**ADDENDUM No. 6**  
**STREET DEPARTMENT GARAGE FACILITY - 2024**

**City of Oregon**  
**Department of Public Service**

**MEZZANINE PLUMBING PLAN**  
SCALE: 1/8"=1'-0"

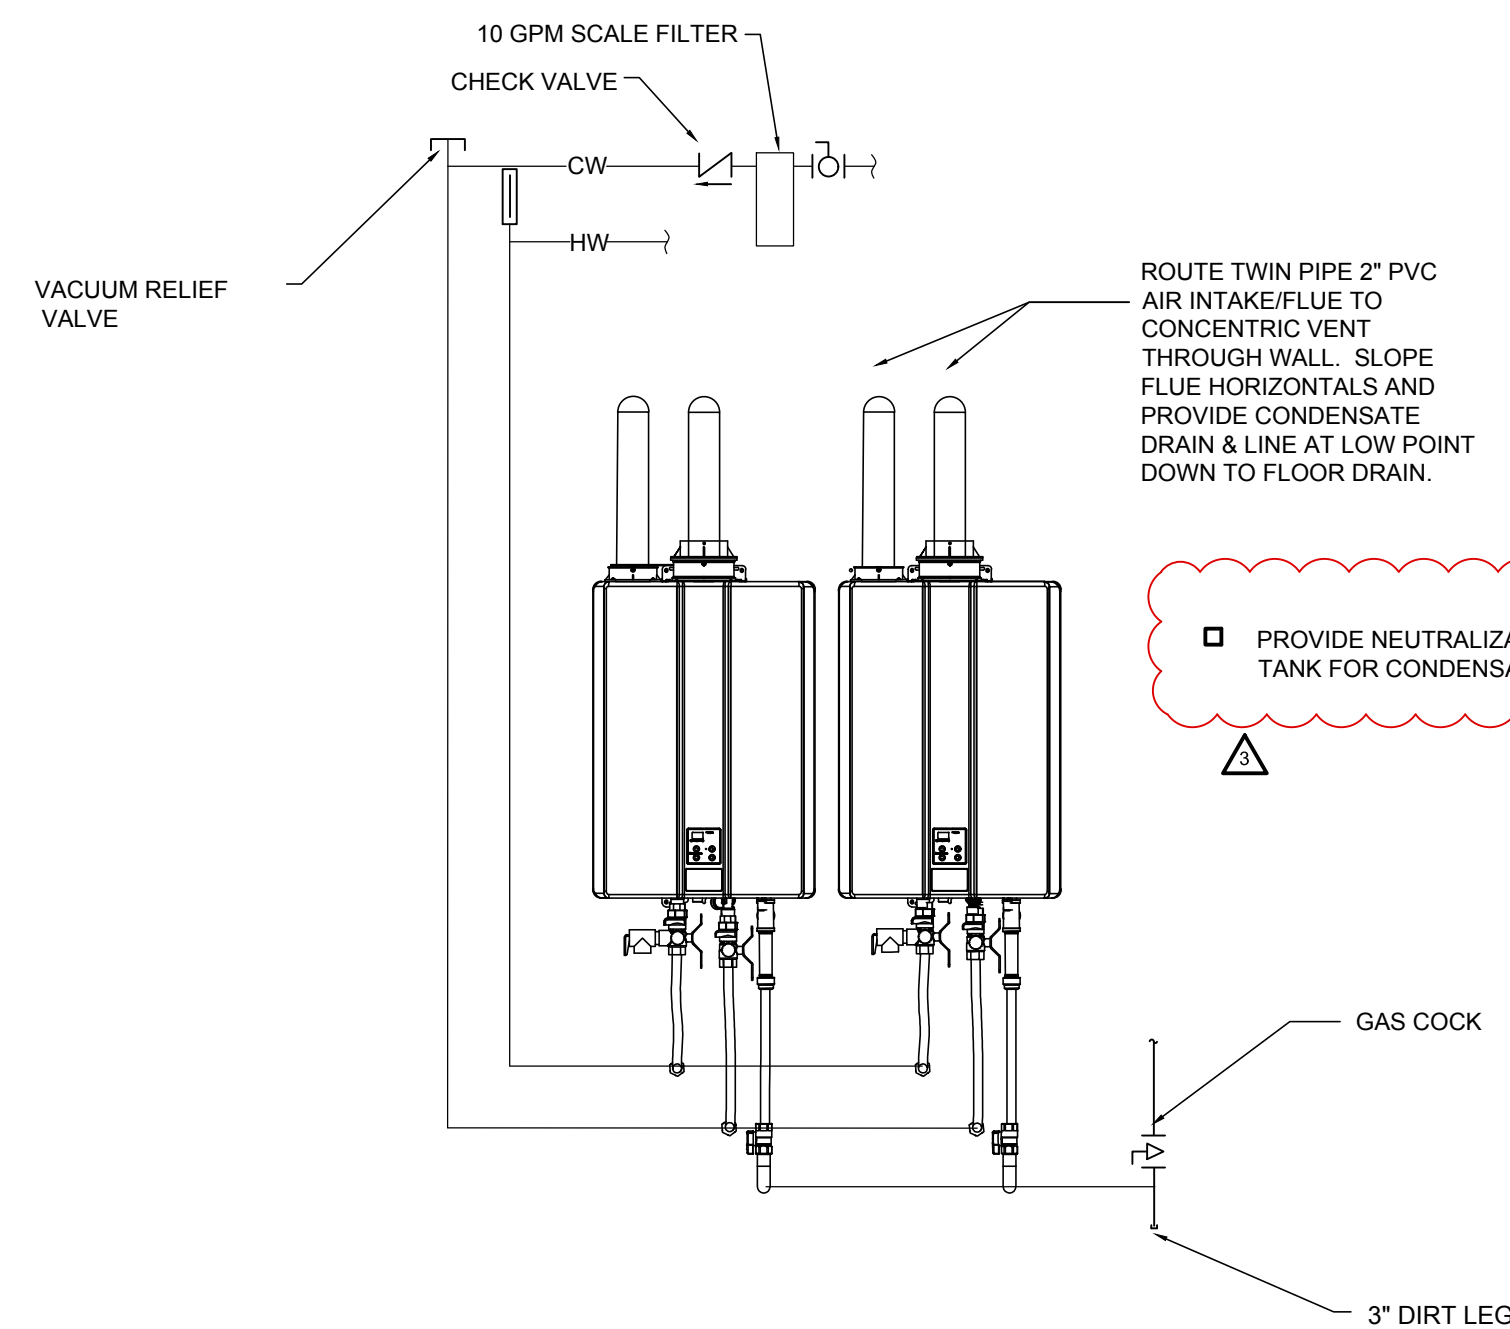
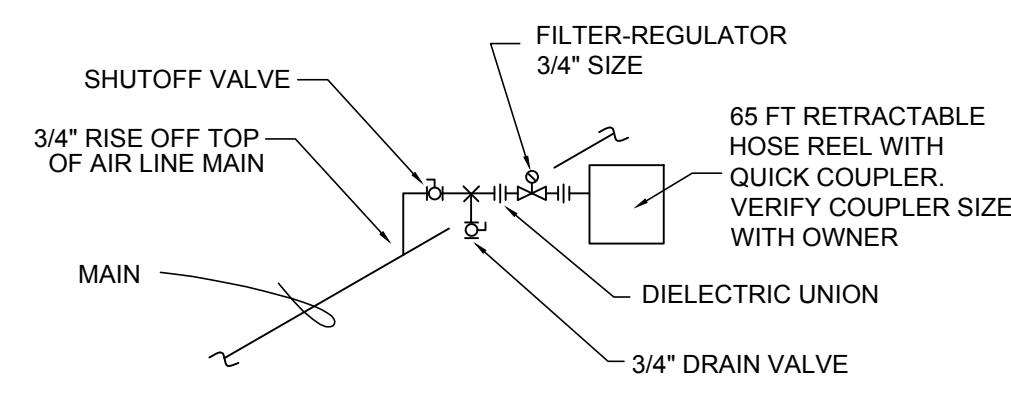
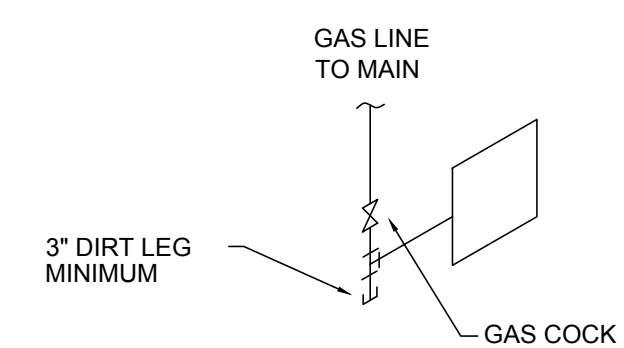
3) **Drawing P1.1 Tankless Water Heaters**

- Provide an appropriately sized neutralization tank for water heater condensate.

- 7) **Bidder Question:** *I see there is an allowance for a new air compressor. The one shown on the plumbing drawings says relocated. Assuming this will be a new air compressor and not an existing one we need to figure relocating and reinstalling? Also, will there be a piping detailed issued for the AC?*

**Architect/Engineer Response:** Columbia Gas to install underground service line and meter setting. Contractor is responsible for gas piping after the meter. See revised plumbing drawing P1.1 and C6.

**Architect/Engineer Response:** A new compressed air system shall be installed, no relocated air compressor. See revised plumbing drawing P1.1.
